05-29 Windsor Gate Plaza
Rt. 94 (Taconic)

TOWN OF NEW WINDSOR
PLANNING BOARD
REVIEW COMMENTS

PROJECT NAME: WINDSOR GATE PLAZA SITE PLAN AMENDMENT
 (ADDITION TO EXISTING CMML. BUILDING)
PROJECT LOCATION: NYS ROUTE 94
 SECTION 67 – BLOCK 6 – LOT 18.1, 18.2 & 17
PROJECT NUMBER: 05-29
DATE: 22 FEBRUARY 2006
DESCRIPTION: THE APPLICATION PROPOSES A 9890 S.F. TWO-STORY ADDITION TO THE EXISTING 7544 S.F TWO-STORY COMMERCIAL BUILDING ON LOT18.1. AS PART OF THE APPLICATION THE THREE LOTS ARE BEING COMBINED. THE PLAN WAS PREVIOUSLY REVIEWED AT THE 14 SEPTEMBER 2005 AND 14 SEPTEMBER 2005 PLANNING BOARD MEETINGS. THE APPLICATION IS BEFORE THE BOARD FOR A PUBLIC HEARING AT THIS MEETING.

DATE: 5/7/05 SCALE: 1" = 30' JOB NUMBER: 04039-CE1 SHEET NUMBER: 2 OF 6

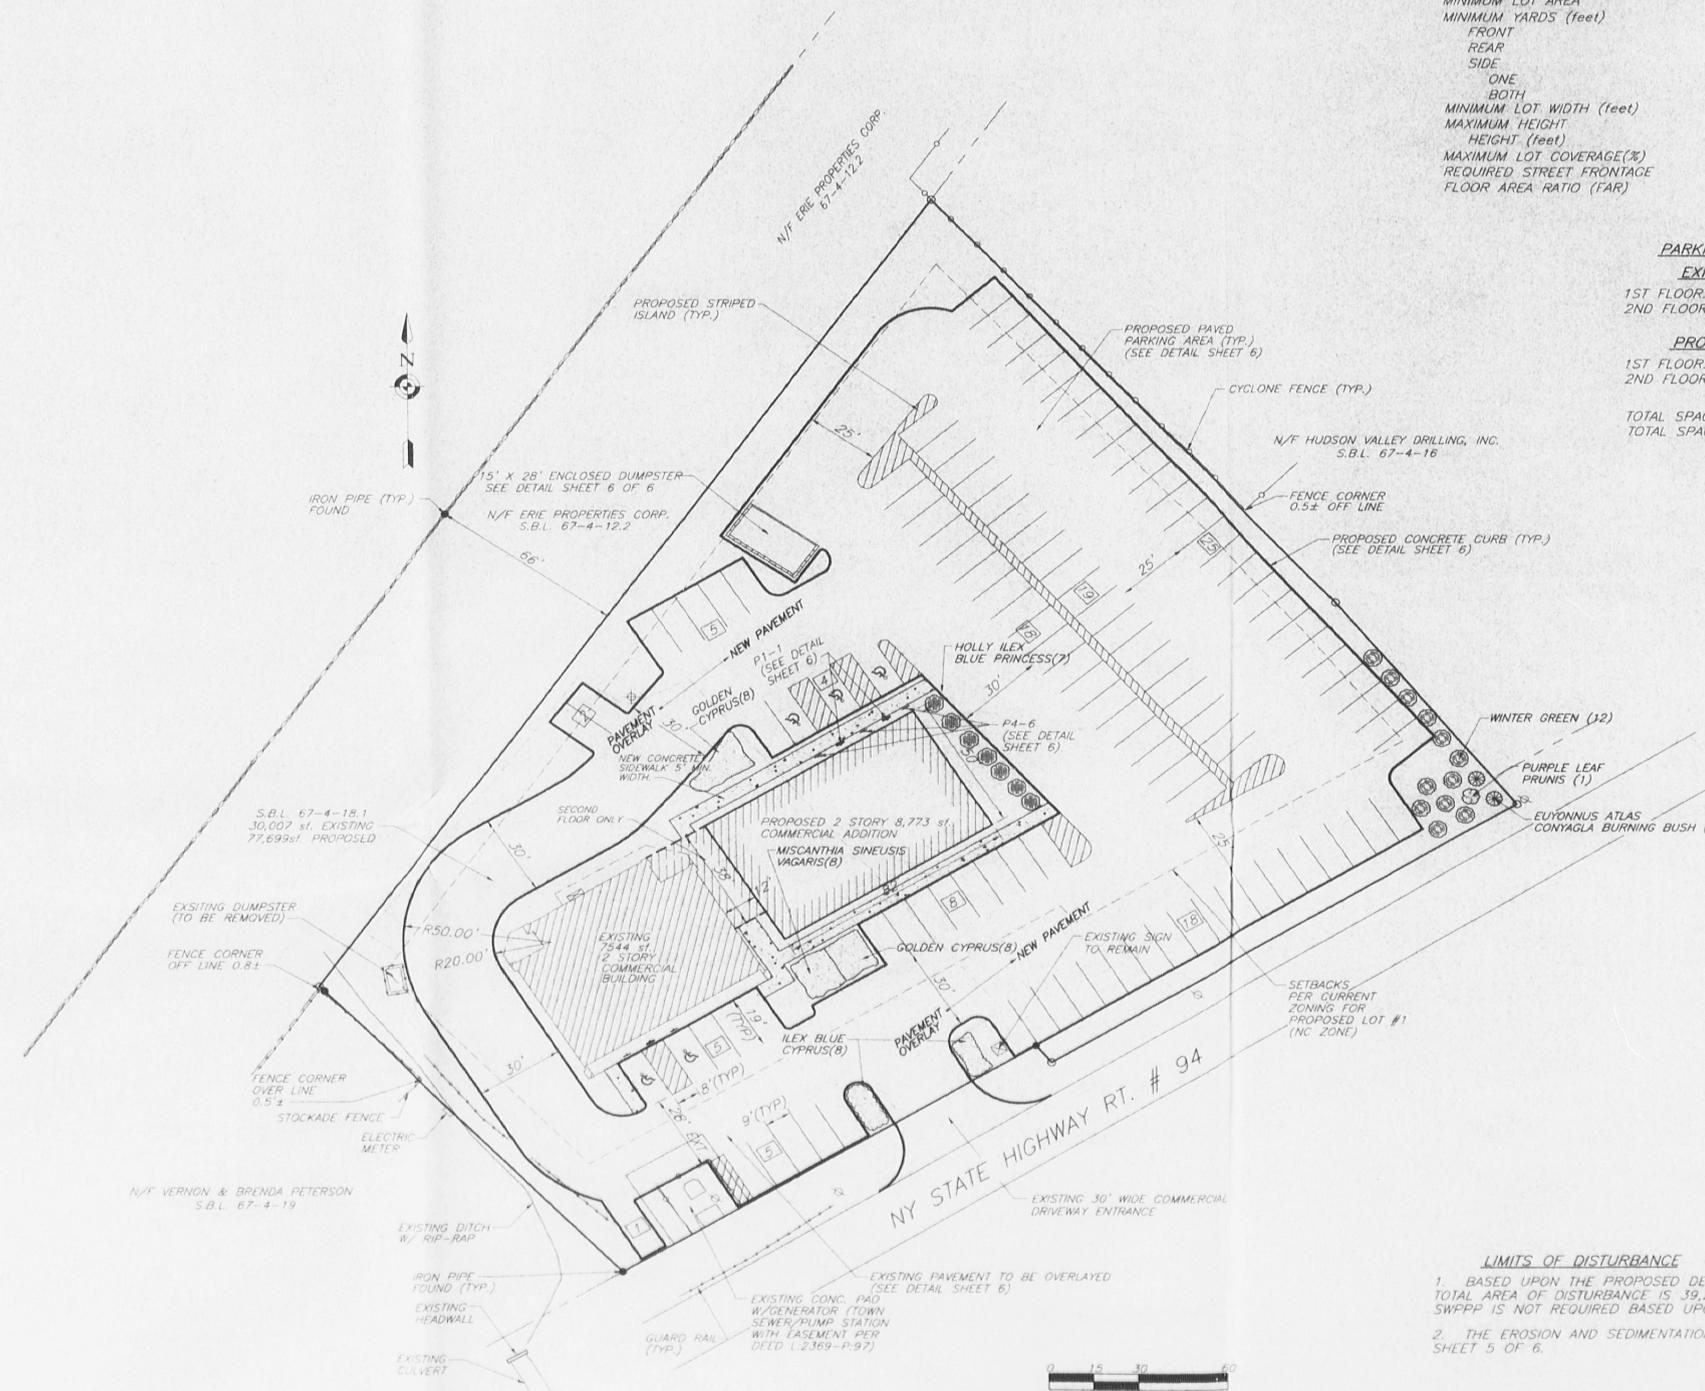
- We previously advised the applicant's consultant of the new code requirements for the "No Parking - Any Time" sign. It has been added but it obstructs the access aisle. Please located in acceptable location.

- The parking calculation “rounds up”. As such, the required parking is 117.
 - The plan notes “existing sign to be relocated”, but does not indicate to what location. Perhaps the adjoining island can be widened, to include the partial parking space, and sign moved there.

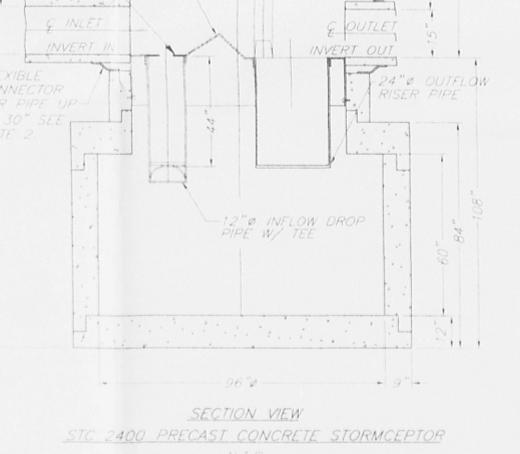
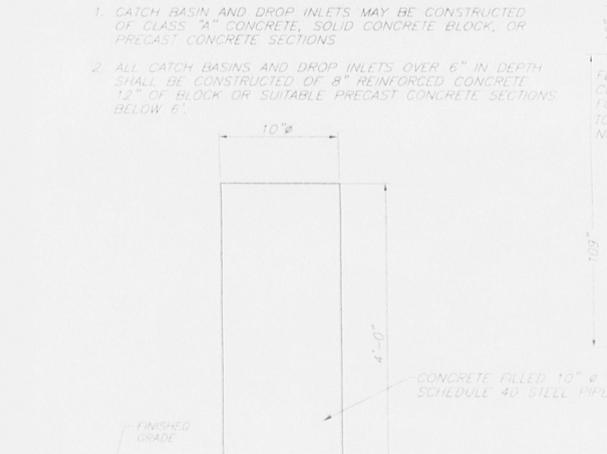
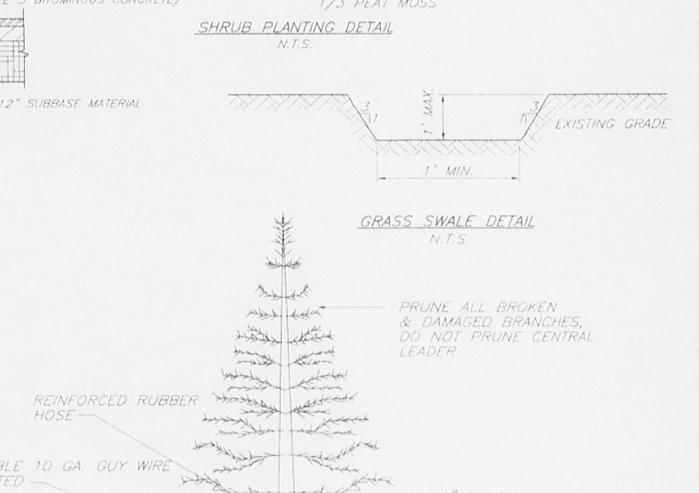
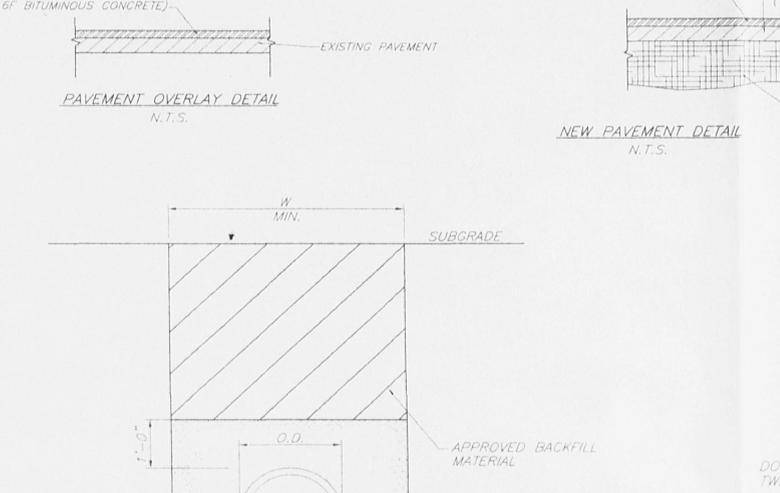
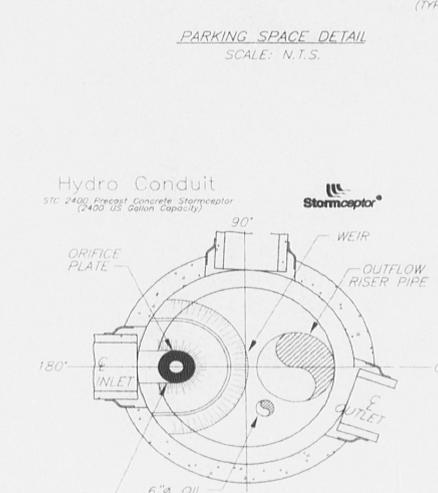
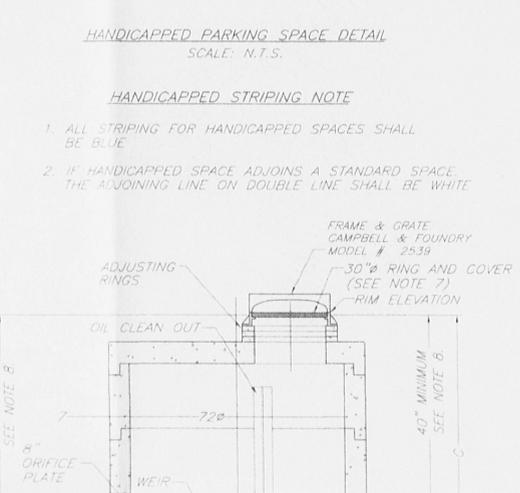
- The double row of parking spaces on the east side of the building has offset alignment. These should be aligned, and the one “lost” space could be replaced with an additional space at the rear.
- The pavement detail on sheet 6 implies that *all pavement will be removed and replaced* with all new pavement. If this is not intended, a revised detail should be provided.

MR. BROWN: We show it on sheet 6 as a three sided architectural block but I can note that it will be in conformance with the architectural style of the

MR. ARGENIO: Mark, the comment here says the enclosure is chain link fence.

MR. ARGENIO: Show bollards, you don't need a dozen of them, but the idea is to keep the garbage truck from hitting it, make due note. I built a job in the Town of Newburgh and we installed 16 dumpster enclosures and after the dumpster enclosures were constructed and built, guess what, the owner and the architect and the engineer found out the dumpsters don't fit in the enclosures. So due diligence.

MR. ARGENIO: I have a question and again this is probably by Mark the pavement detail on sheet 6 implies all pavement will be removed and replaced with all new pavement, is that intended or not intended?

MR. EDSALL: Maybe what you could do is give us a detail that indicates that you're going to take all the non-paved areas or areas that are in failure and show us what you're going to put in for a pavement structure there and just indicate that it all will be overlaid so you have a new finish surface. I'm sure that will save them a lot of money because I looked at the plans, I didn't see a reason why you wanted to rip everything out.
